Re: Initial Submission Review – Parkland Village 2 – Site Plan and Plat

Application Number: **DA-2289-01**

Case Numbers: **2022-4054-00; 2022-3092-00**

Initial Submission Review

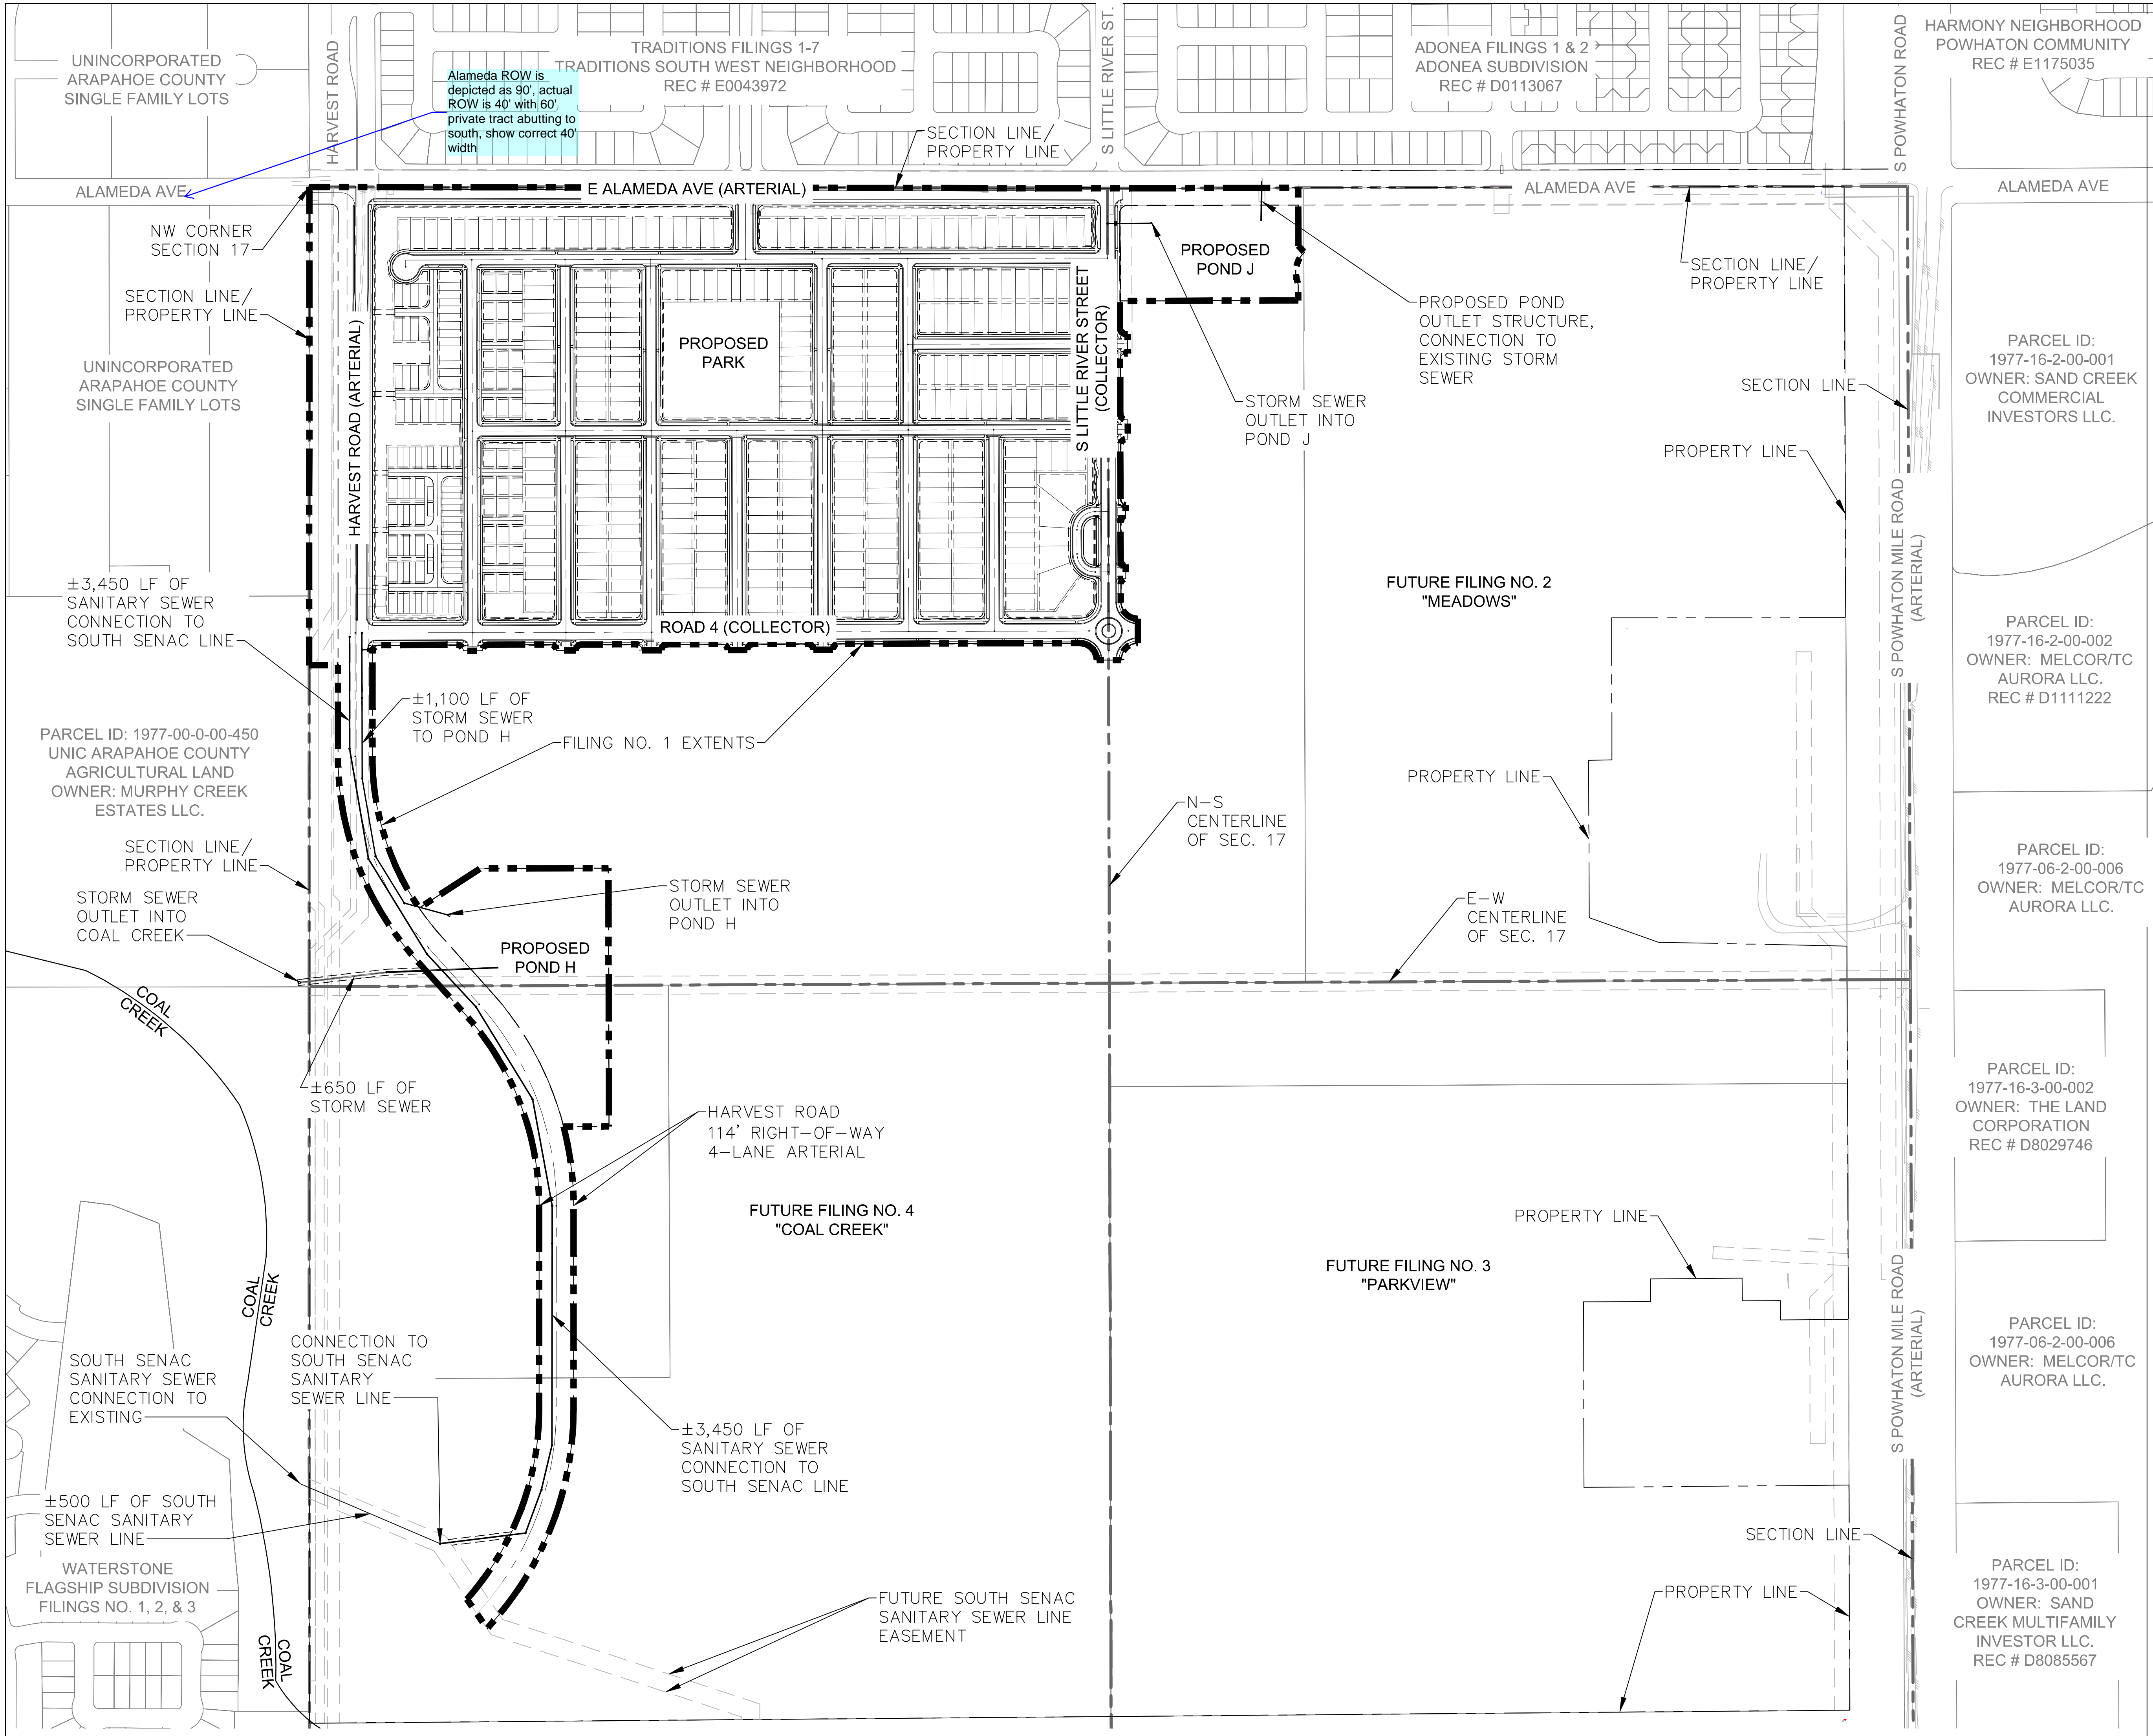
1. Sheet 5 – Alameda ROW is depicted as 90'. Actual ROW is 40' with a 60' private tract abutting to the south. Please show correct 40' width.
2. Sheet 7-
 - a. Show current Alameda Ave. pavement alignment on site plans.
 - b. 40' ROW Alameda Ave. Show on plans.
 - c. 60' Private Parcel 1977-00-0-00-218. Show on plans.
 - d. Any roadway improvements south of section line (south 40' ROW limit) will require ROW acquisition, please coordinate with John Wannigman, jwannigman@arapahoegov.com, Arapahoe County PM for Gun Club-Alameda Improvements Project currently ongoing.

Alameda ROW is depicted as 90', actual ROW is 40' with 60' private tract abutting to south, show correct 40' width

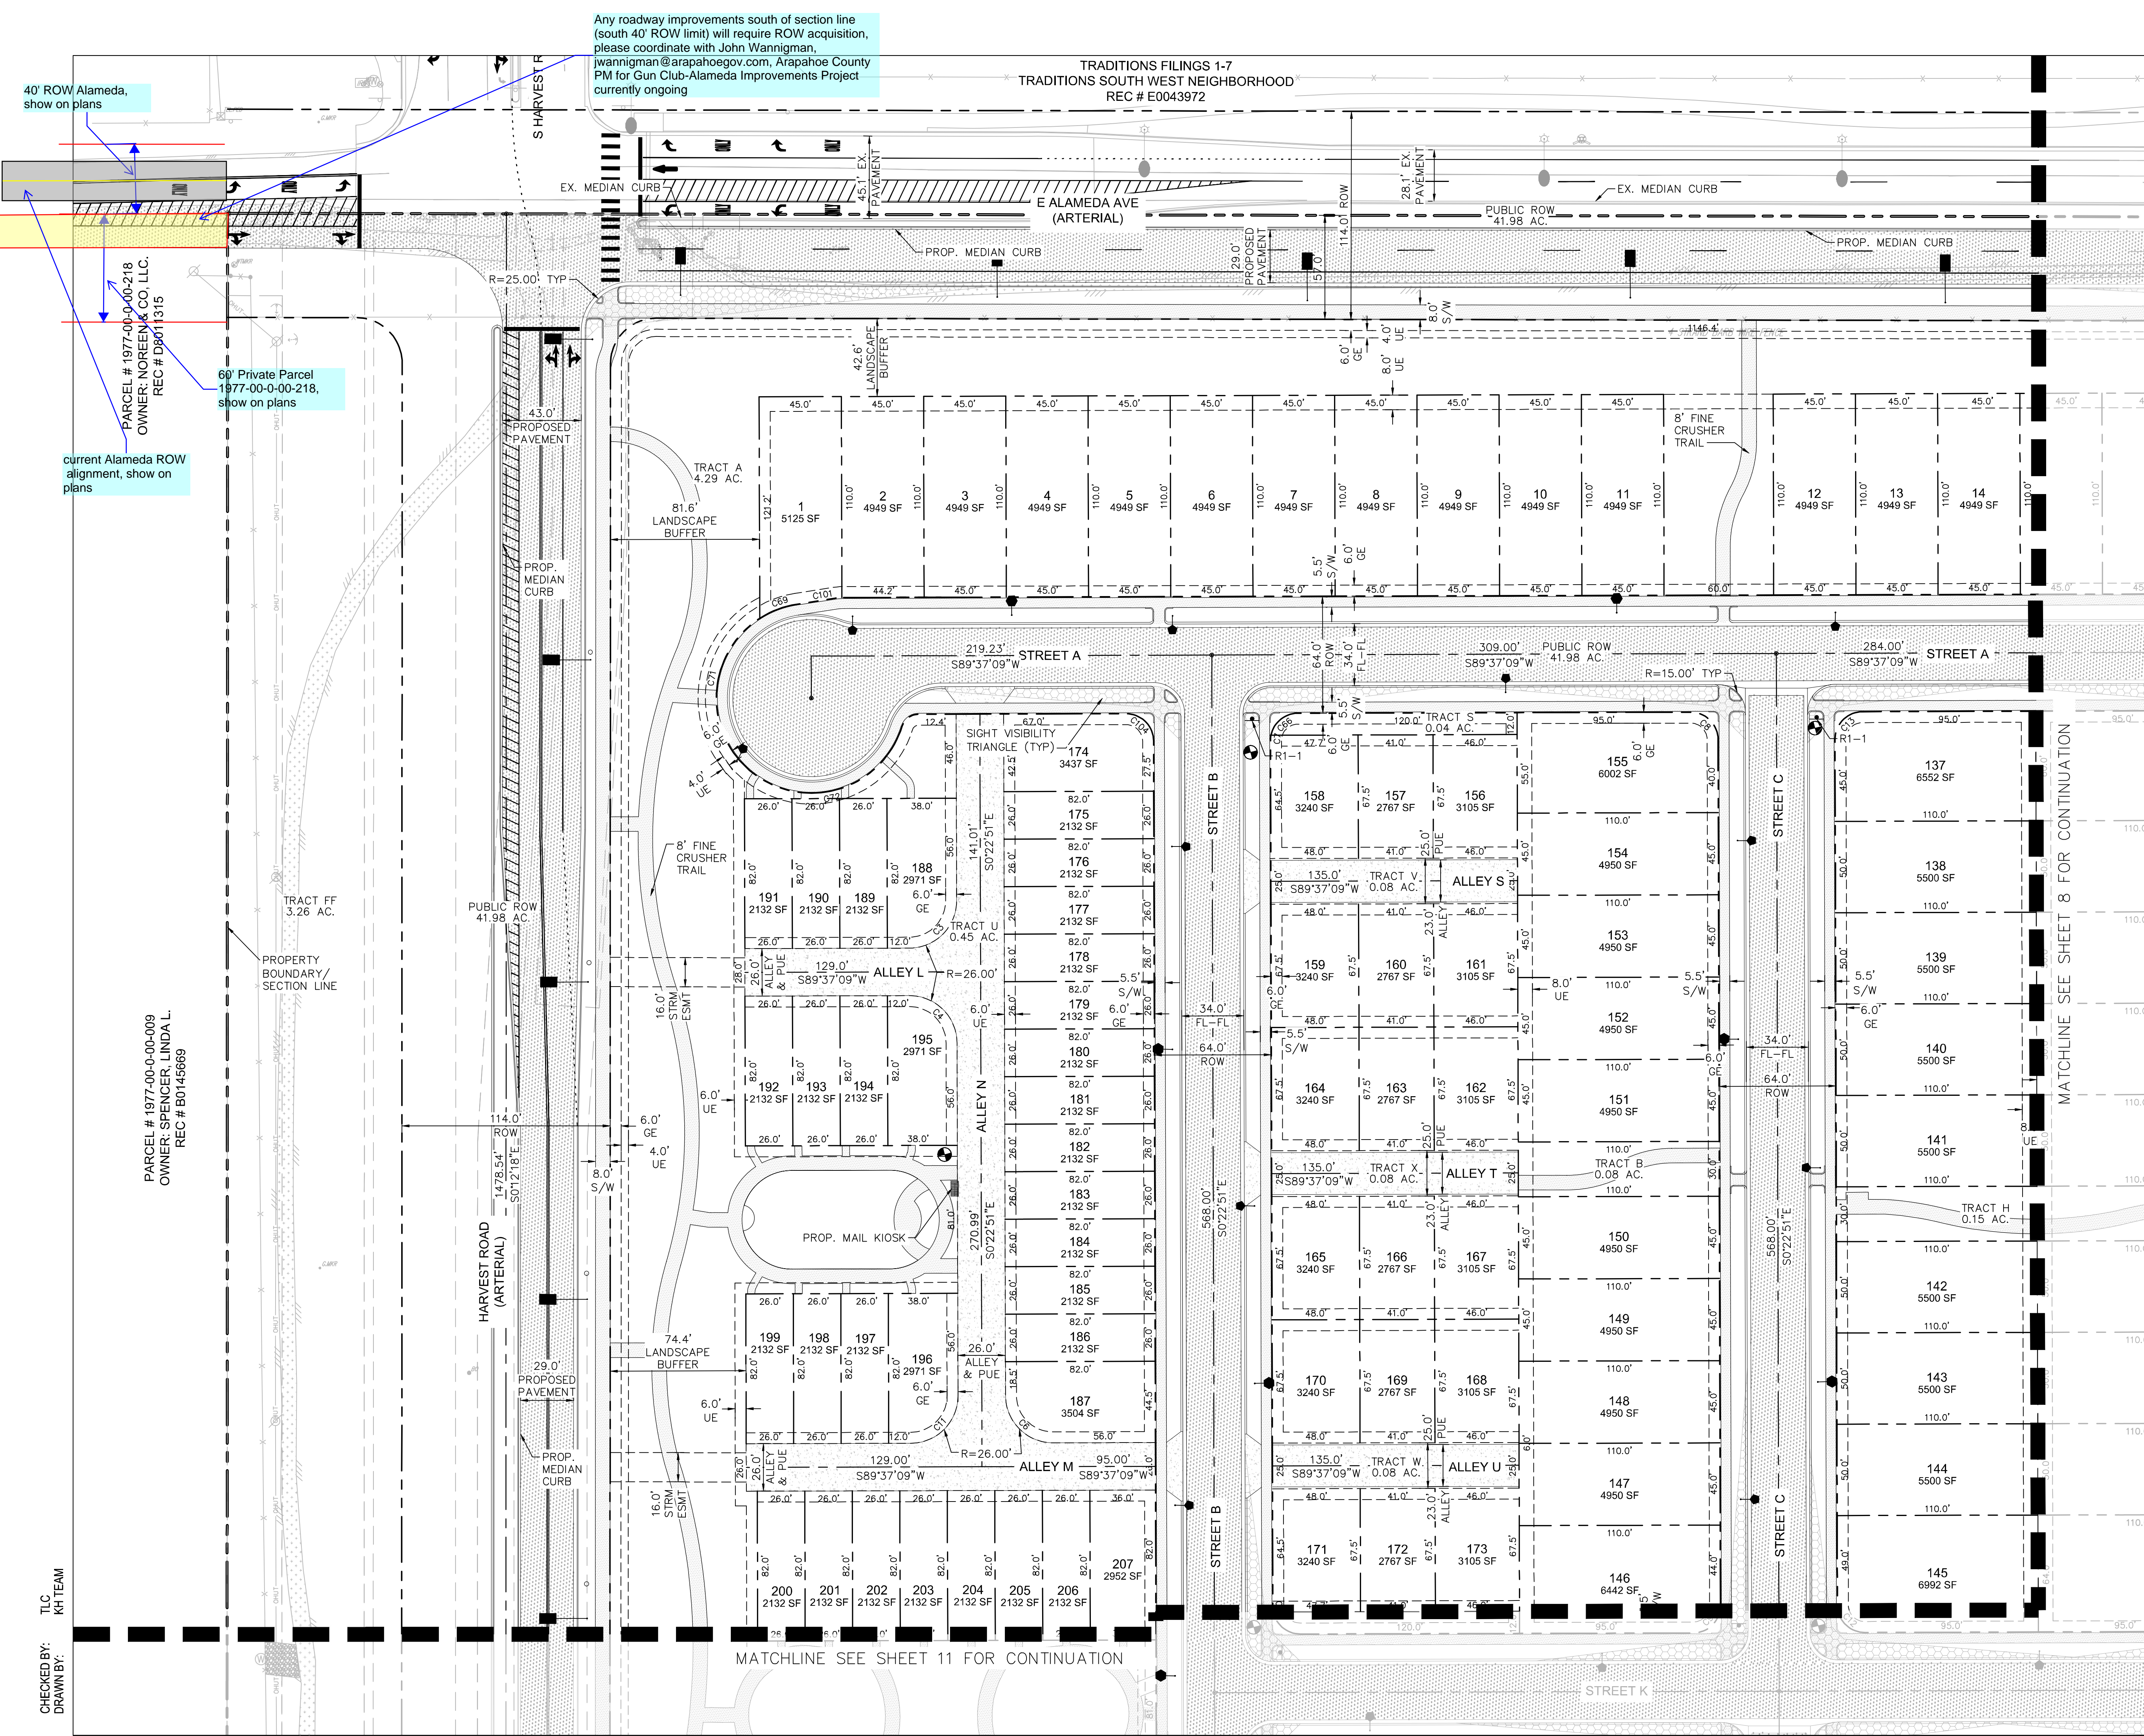
- d. With current Alameda alignment, EB lane shift of approx.. 27' to south would be required over 220' length across intersection with Harvest (includes 75' easement west of harvest ROW). Show on site plans with ROW boundaries and current Alameda road alignment.
